## APPLICANT'S SUPPLEMENTAL APPLICATION NARRATIVE

DATE: December 1, 2023

APPLICATION: City Casefile #0701-21-1 DR

PROPOSAL: Design Review to construct a building that includes processing, storage, and retail sales of fish and shellfish.

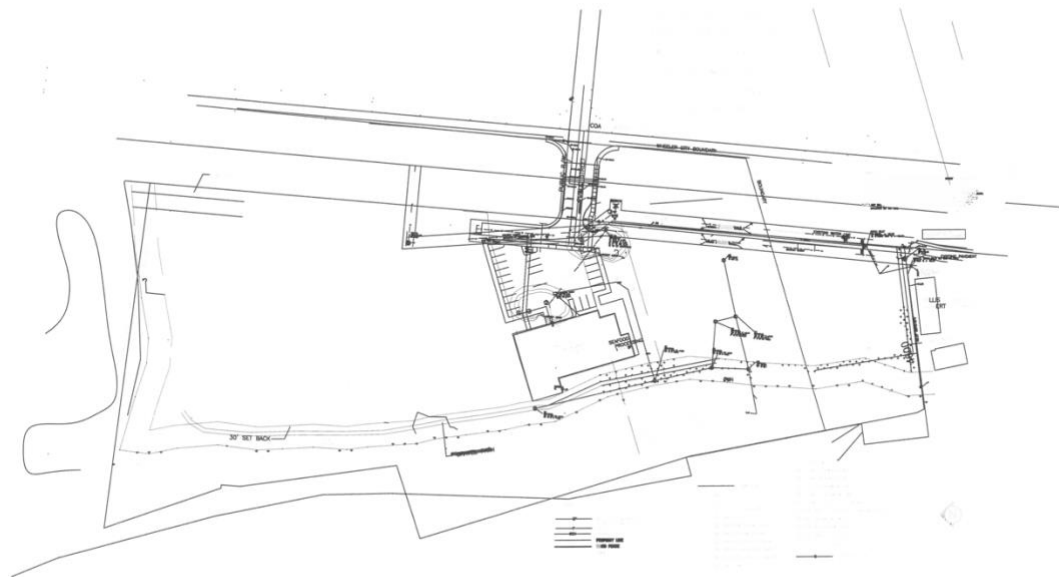
- The application did not demonstrate "how the height and scale of the proposed buildings will be compatible with the site or adjoining buildings."

- The application did not demonstrate “how the materials proposed will promote harmony with the structures and site” or “how the materials are compatible with the natural elements.” The application did not identify the “natural elements.” Because the property is “generally pristine in its natural condition,” the City requires greater attention to materials compatibility.

Supplemental Response: The project design is compatible with the site's layout and topography. As shown in the site plans, the footprint of the building and landscaping

follow the curved Marine Drive alignment to the east and the sinuosities of the Nehalem Bay shoreline to the west. The project design is compatible with the site in terms of height and scale. The building will not exceed the Zones' height limitation of 24 feet, and the building consolidates a commercial and an industrial use, thereby reducing the structure's footprint and impact on the natural shoreline. As shown on the site plans submitted with the original application, reproduced below, the building occupies only a small portion of the site's total acreage:
